E4433B-11**S E R V I C E N O T E**Supersedes:
NONE**ESG “B” Signal Generator E4433B**

Serial Numbers: [0000A00000 / 9999Z99999]

Defective Waveform Sequence SRAM on the Dual Arbitrary, UND board (A5) and iDEN Dual Arbitrary, Special Option H60 board causes waveform become distorted when playback.**To Be Performed By: Agilent-Qualified Personnel****Parts Required:**

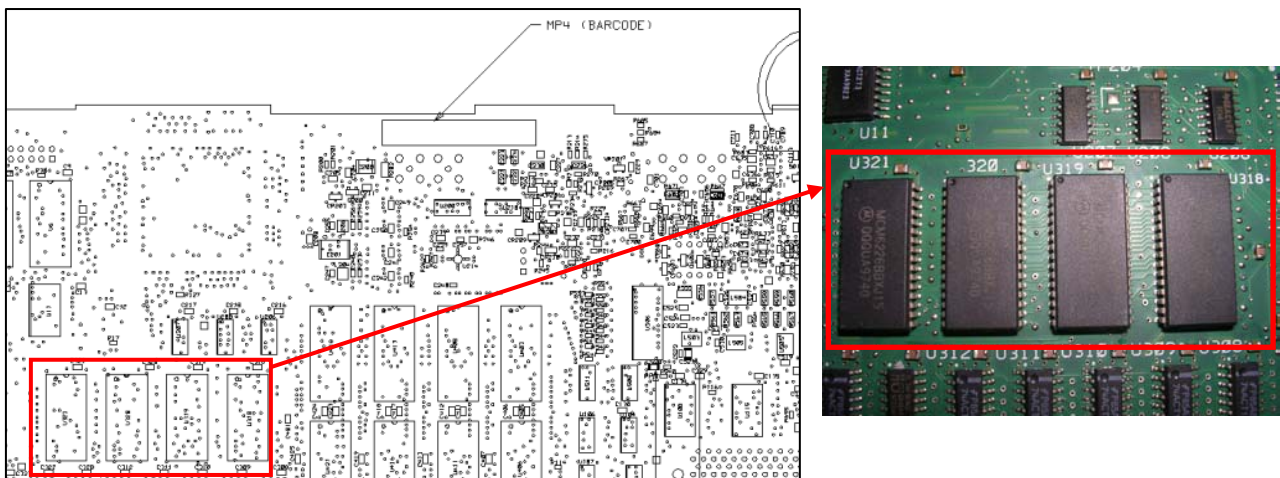
The ESG-B D/DP Family of Signal Generators has been experiencing failures in the UND (E4400-60187) and Option H60 (E4400-60186) board assemblies. This is due to a failure of the waveform sequence SRAM ICs. There are total 4 affected waveform sequence SRAM ICs on the UND and Option H60 assembly, designator U318, U319, U320, U321. The failure will cause the waveform playback become distorted. This may happen immediately after Arbitrary Function is turned on, or after it has been play-backed for a short period of time. This potentially happened when large waveform files are being playback. All ESG-B D/DP units with the symptoms mentioned above required the waveform sequence memory chips to be replaced. The kit, E4400-60753 contains 4 pieces of the SRAM ICs.

1. Repair on failure.
2. Prevent future occurrences due to a defective waveform sequence memory chips (U318, U319, U320, U321) by replacing the 4 affected chips.
3. Locate the U318, U319, U320 and U321 which are located at the bottom side of the UND or H60 board.

4. Replaced the affected components. **Caution:** Please use the appropriate soldering tools and you must be certified to perform the soldering to prevent any quality or reliability issue due to soldering workmanship.
5. Once the affected components had been replaced, perform:-
 - i) Dual Arb Waveform Generator Check. This test can be performed by using the TME software or the ESG-B Classics Software, and
 - ii) If customer waveform is stored in the NVARB RAM, playback the waveform and observed on the oscilloscope for any waveform distortion.
